REMARKS

Application No.: 10/003,293

AMENDMENTS TO THE DRAWINGS:

fig. 15

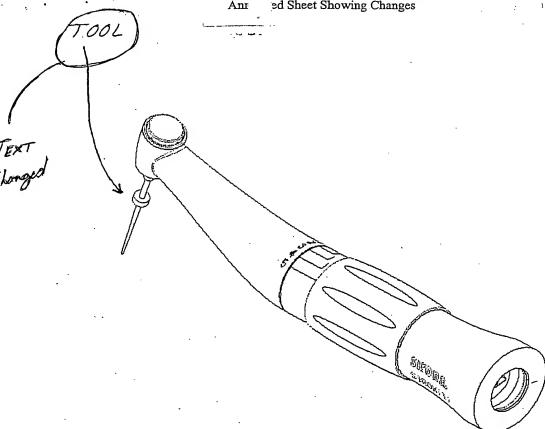
The Office Action further states that the limitations of "a reduction gear," "a drive tool" and "a tool" must be shown. With regard to the aforementioned objection regarding "a reduction gear," Applicant respectfully asserts that the limitation of reduction gear 34 is shown in original Fig. 3. With regard to the aforementioned objection regarding "a drive tool" and "a tool" Applicant respectfully notes that a drive tool, such as the root canal tool, has been illustrated in Fig. 15.

With regard to new Fig. 15, the Office Action states that Fig. 15 contains new matter. In the interest of expediting prosecution of this application, Applicant respectfully proposes amending Fig. 15 to show a "tool" as it would be connected to the device according to claim 1.

The attached drawing sheets include changes to Figs. 3 and 15, wherein the connection point corresponding to the connection point of a tool working with a high rotation speed is shown in Fig. 3, and a drive tool, such as the root canal tool, has been illustrated in Fig. 15.
